MP ref: M2258
DA ref: MCU24/0092
QA: hw.sj.mc

Re: Information Request Response
Development Application seeking a Development Permit for Material Change of Use – Health Care Services (Medical Centre Extension) and Shop (Pharmacy) on land described as Lots 56 and 57 on RP703491 and located at 110-112 Bowen Road, Rosslea

Information Request

Application no:	MCU24/0092
Assessment no:	1806044
Proposal:	Health Care Services (Medical Centre Extension) and Shop (Pharmacy)
Street address:	110 Bowen Road ROSSLEA QLD 4812 112 Bowen Road ROSSLEA QLD 4812
Real property description:	Lot 57 RP 703491 Lot 56 RP 703491
Applicant's reference:	M2258

1 proposed site plan
sk_02 1 : 150

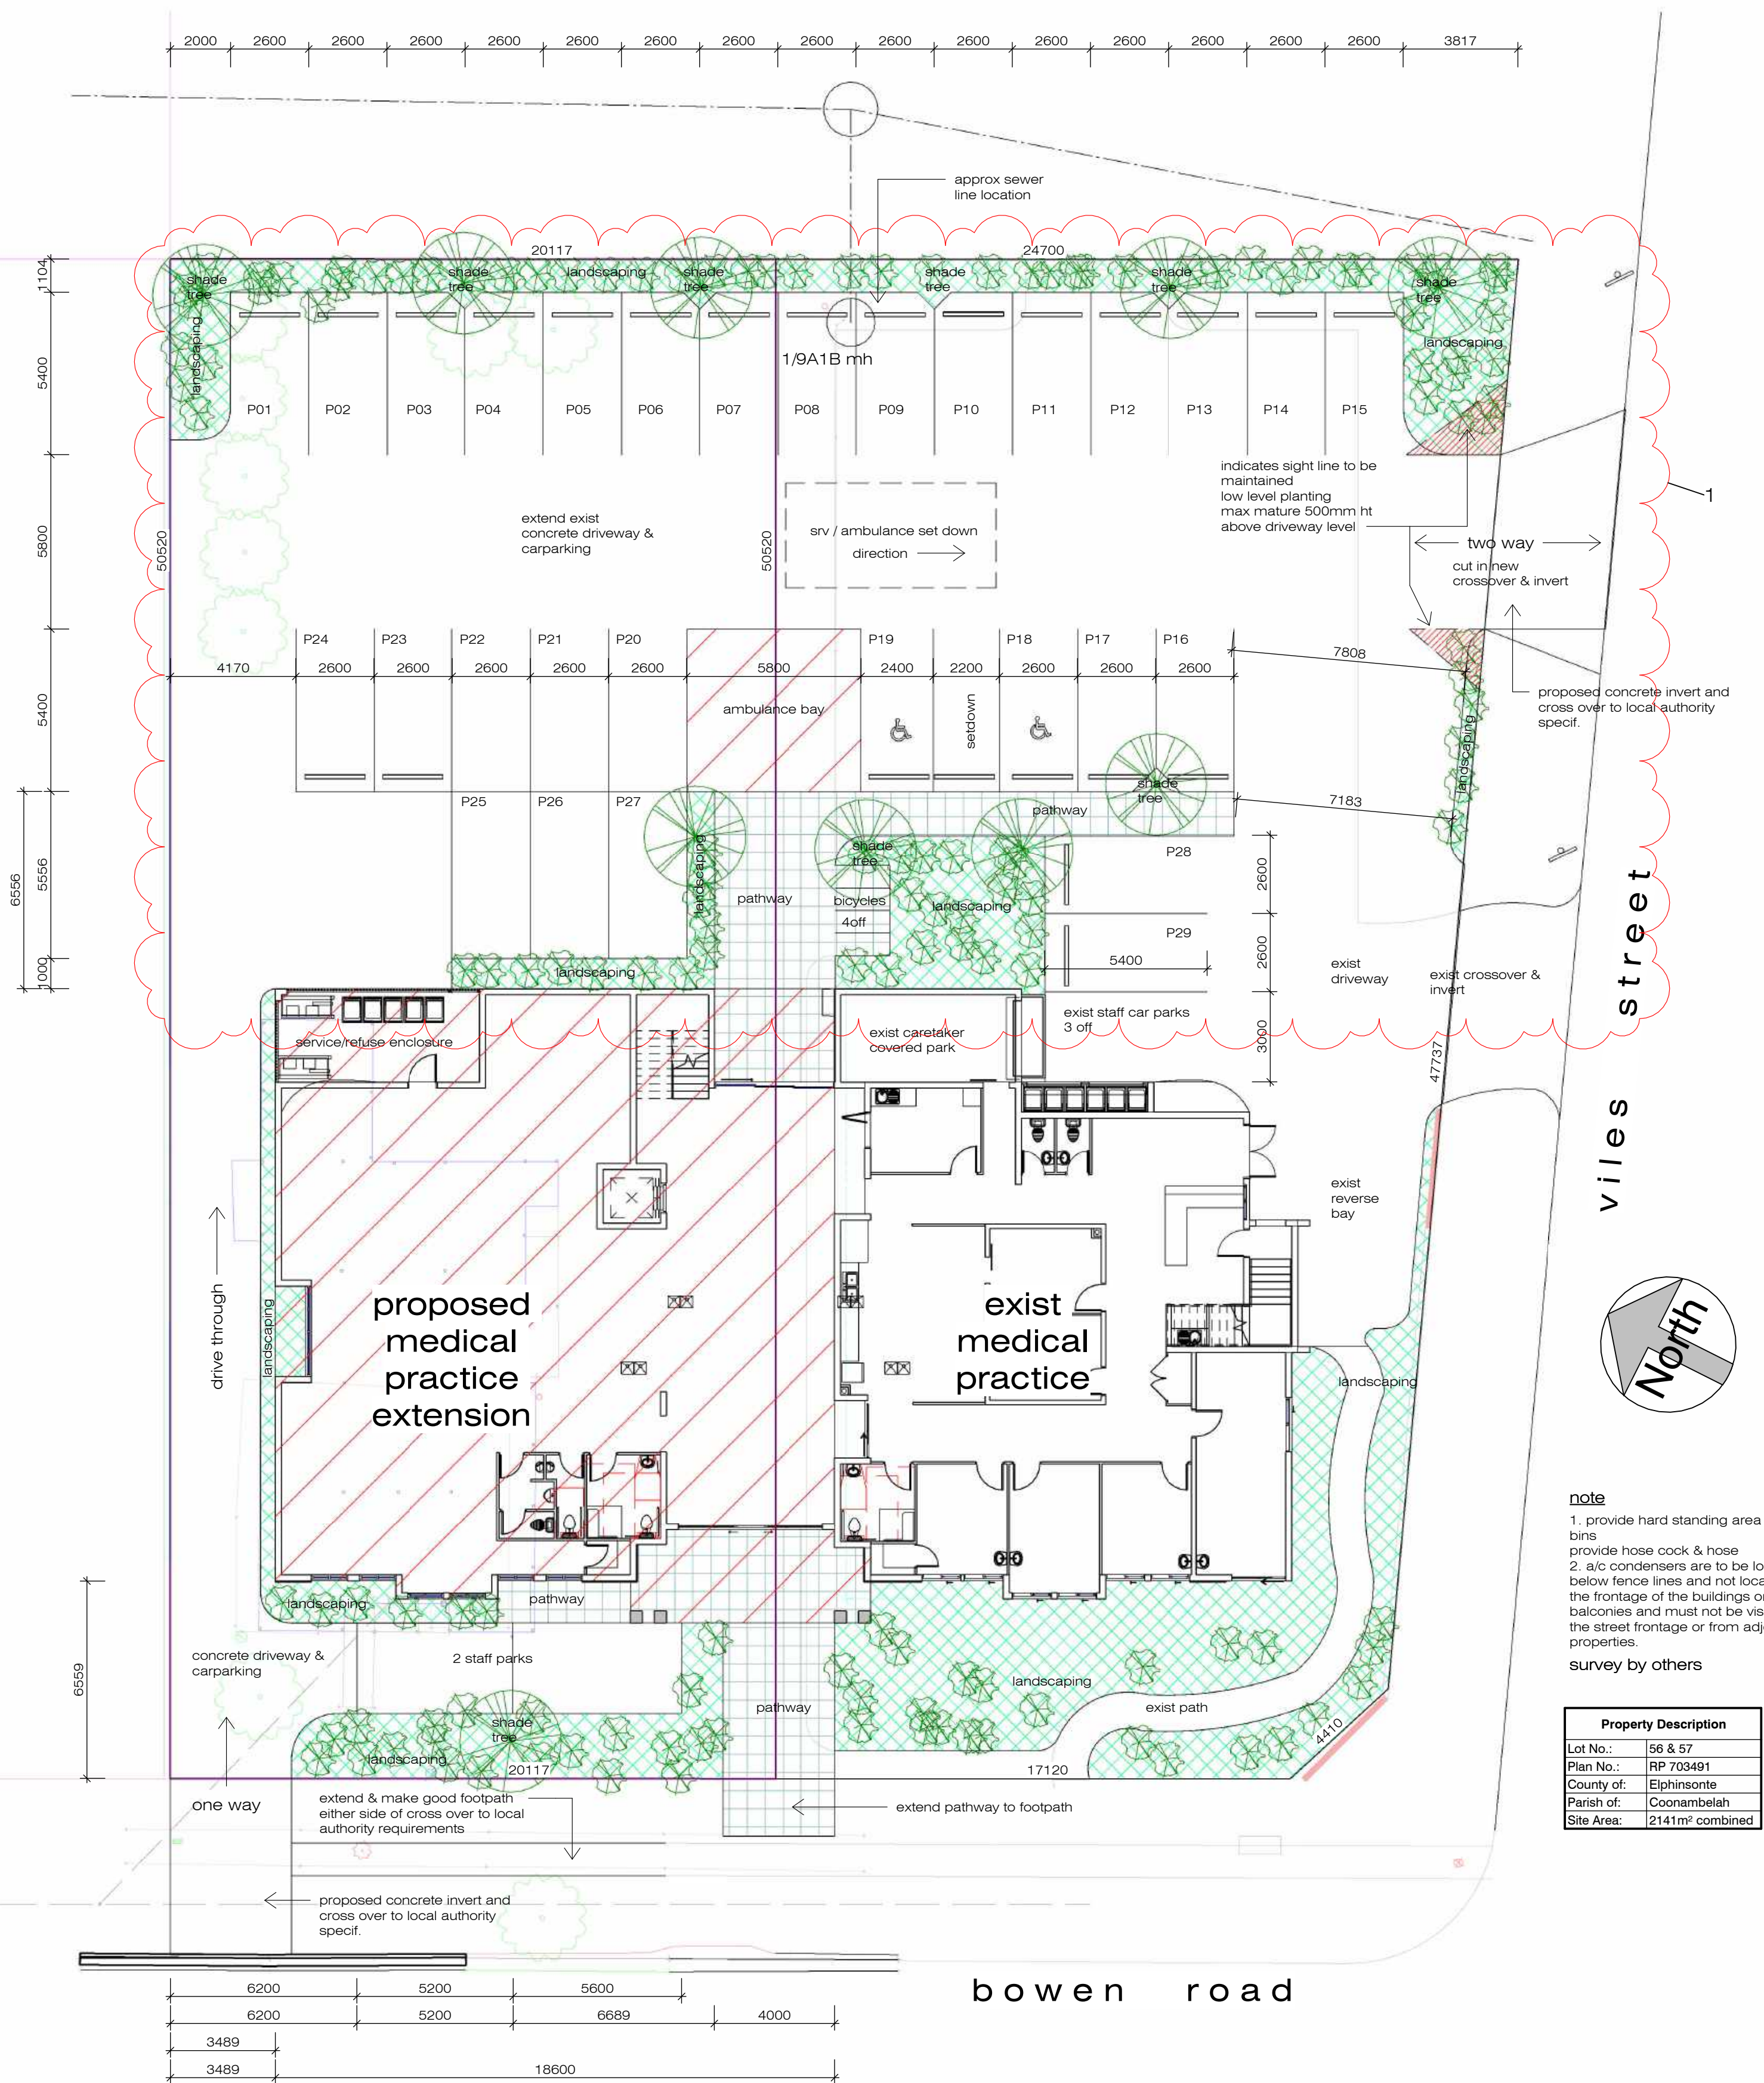
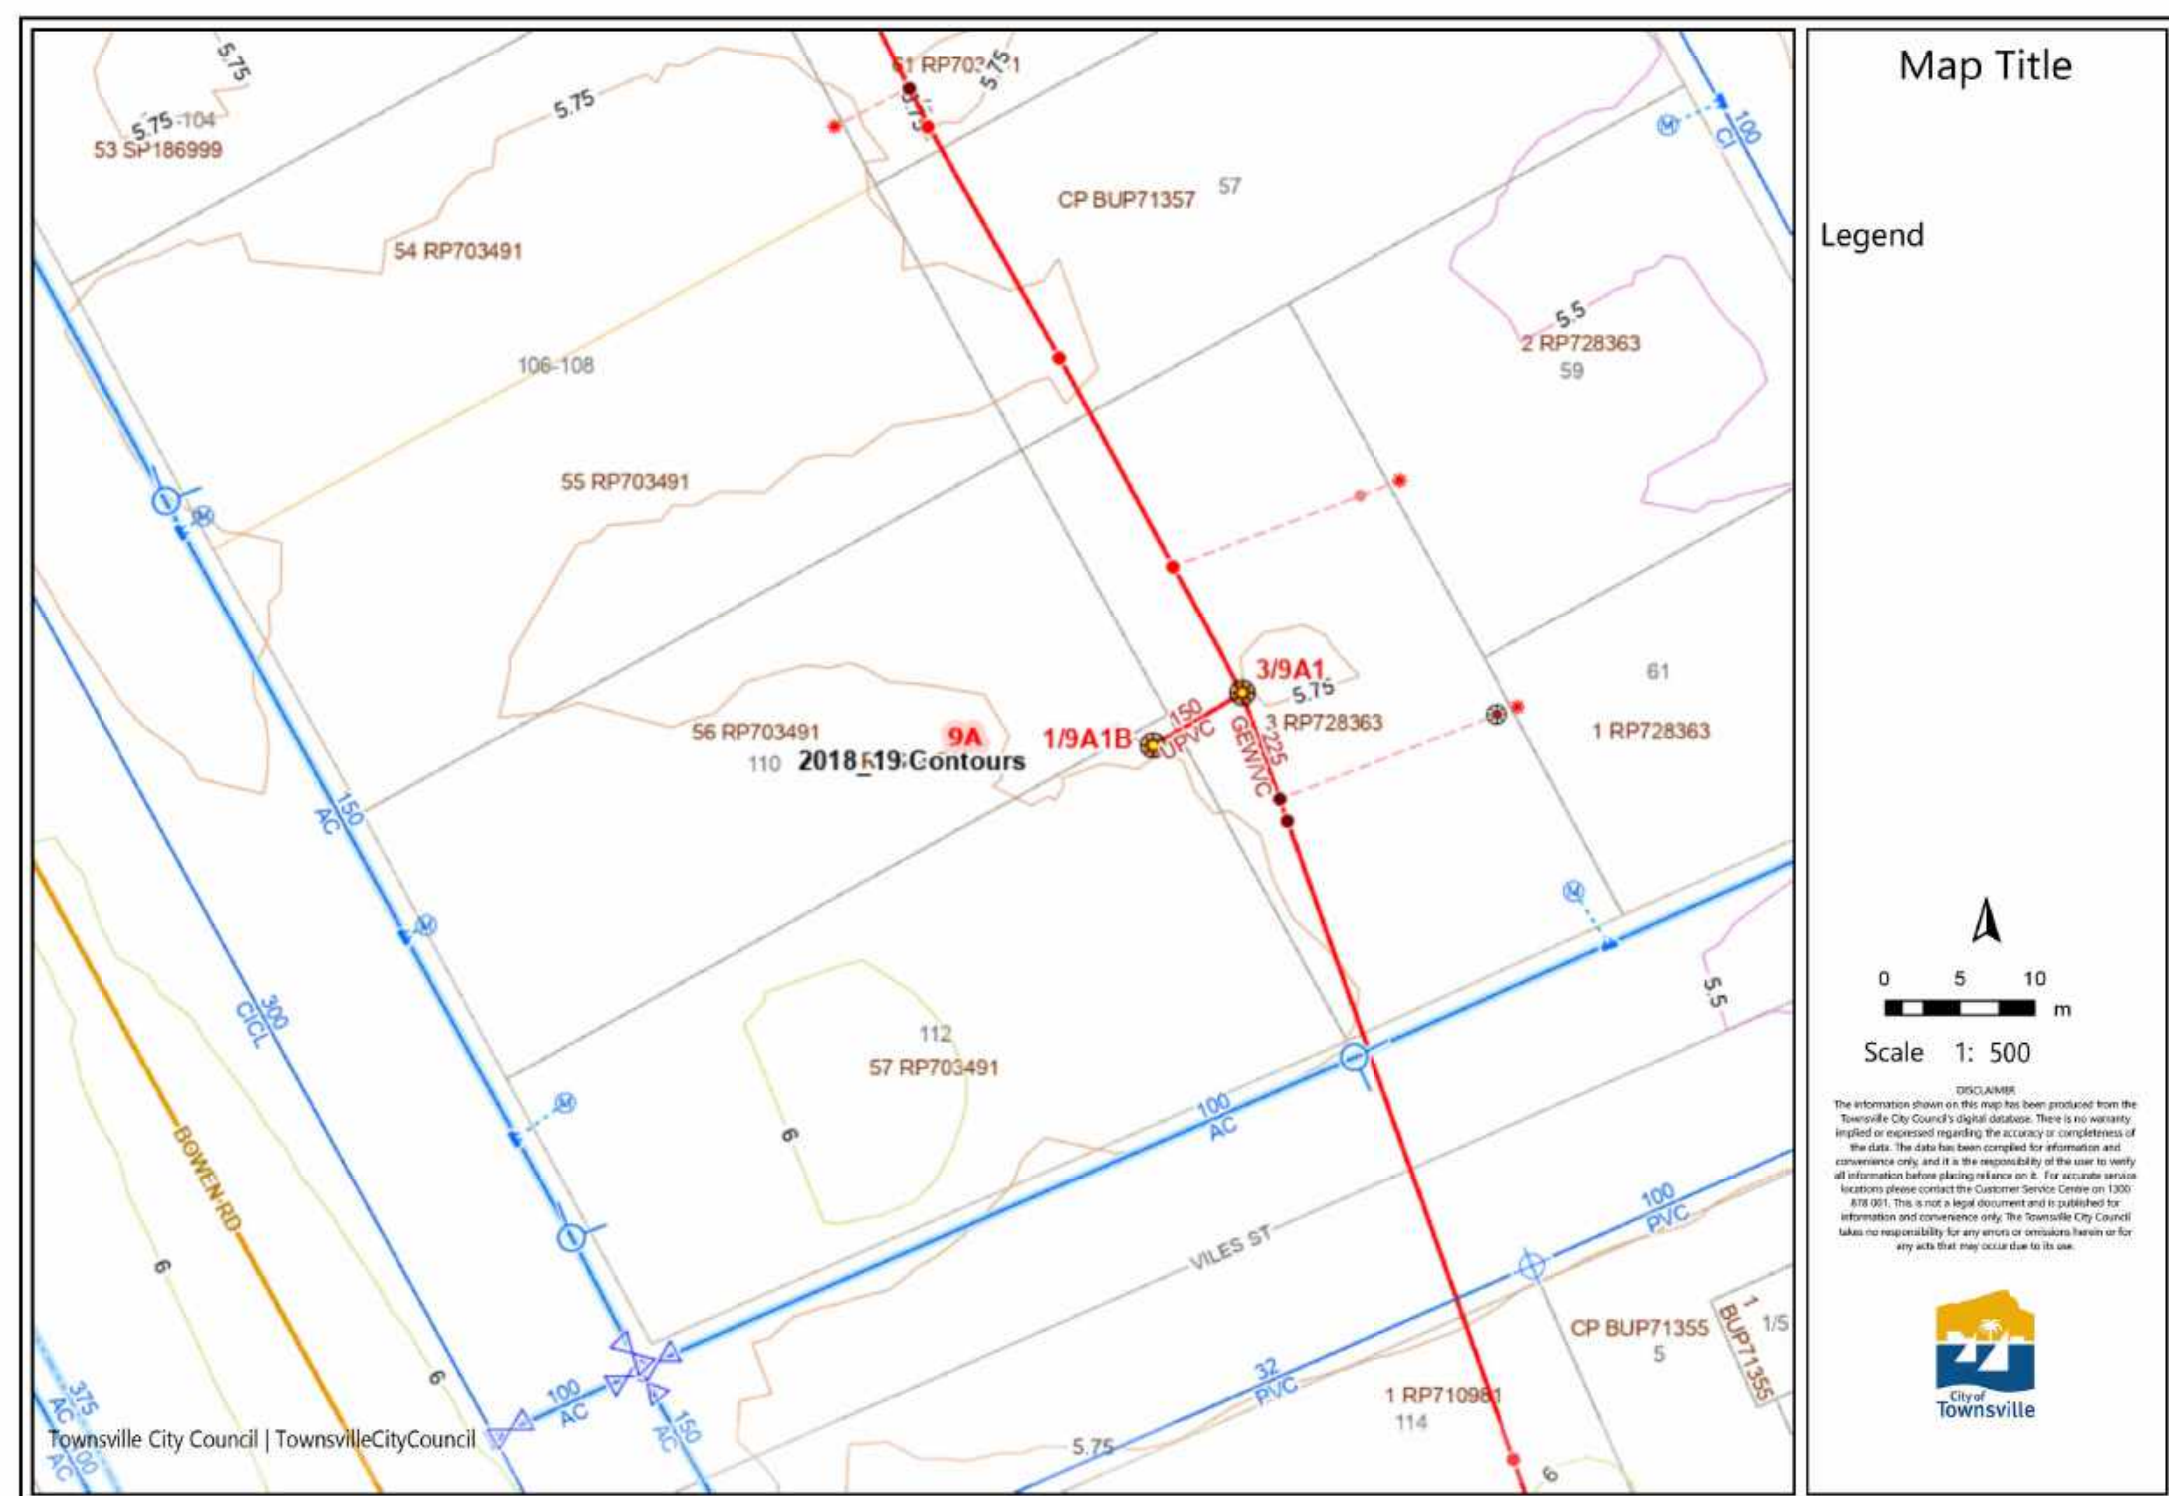
<p>Item 2</p> <p>Carparking and Access</p>	<p>This item requested the Applicant to provide an amended car parking and access plan to include the following changes:</p> <ul style="list-style-type: none"> ▪ the consolidation of driveways on Viles Street; ▪ removal of tandem staff carparking at the front of the site; ▪ provision of a dedicated covered car space for the existing caretaker's accommodation, noting the carparking space shown appears to no longer be accessible to vehicles; ▪ provision of a dedicated ambulance bay; ▪ removal of the 4 tandem staff parks located on the north-eastern side of the proposed extension, noting these parking spaces would be required to reverse into oncoming traffic utilising the Bowen Road access without proper visibility, and are therefore unable to function safely; ▪ turning path diagrams for both cars and service vehicles, illustrating how vehicles will manoeuvre into and out of the staff and public parking spaces; ▪ confirmation that the proposed vehicle access from Bowen Road is free from services and other fixtures, noting that the proposed Site Plan (Plan 23-019) currently shows a pad/box within the driveway; and

- Confirmation that the proposed vehicle access from Bowen Road is free from services and other fixtures, noting that the proposed Site Plan (Plan 23-019) currently shows a pad/box within the driveway; and

Item	Suggested Response
	<ul style="list-style-type: none">▪ detail of the connections between the internal pathway network and the existing Active Transportation Network. <p>In response to this item, Langtree Consulting Engineers reviewed the proposed car parking layout and access arrangements for the proposed development, as a consequence both have been amended, refer to Attachment 3. Also, refer to Attachment 4 and the amended Traffic Impact Assessment (TIA).</p> <p>It is clear from the amended plans, the following changes have been made:</p> <ul style="list-style-type: none">▪ consolidation of driveways on Viles Street;▪ removal of tandem staff carparking at the front of the site;▪ the design of the doors on the bin storage area have been amended to avoid conflict with the caretakers accommodation's parking space;▪ provision of a dedicated ambulance bay;▪ removal of the 4 tandem staff parks located on the north-eastern side of the proposed extension;▪ turning path diagrams for both cars and service vehicles, illustrating how vehicles will manoeuvre into and out of the staff and public parking spaces;▪ the existing Telstra pit will be relocated, with the appropriate authorisation sought from Telstra; and▪ detail of the connections between the internal pathway network and the existing Active Transportation Network. <p>The changes to the car parking layout and removal of the tandem spaces from the north western side of the proposed extension has resulted in the number of parking spaces reducing to 29, one service vehicle/ ambulance space and bicycle spaces.</p> <p>In addition to these car parking spaces, off-street parking is available within the vicinity (i.e. Viles Street and Bowen Road). Further, a percentage of patient will travel to the medical centre by bus, taxi or will get dropped off and picked up from the medical centre by family or friends. The medical centre is also well connected to the existing footpath network along the Bowen Road frontage and is in reasonable walking distance for some patients.</p> <p>It is considered that the above response, amended plans and revised TIA, sufficiently address this item.</p>
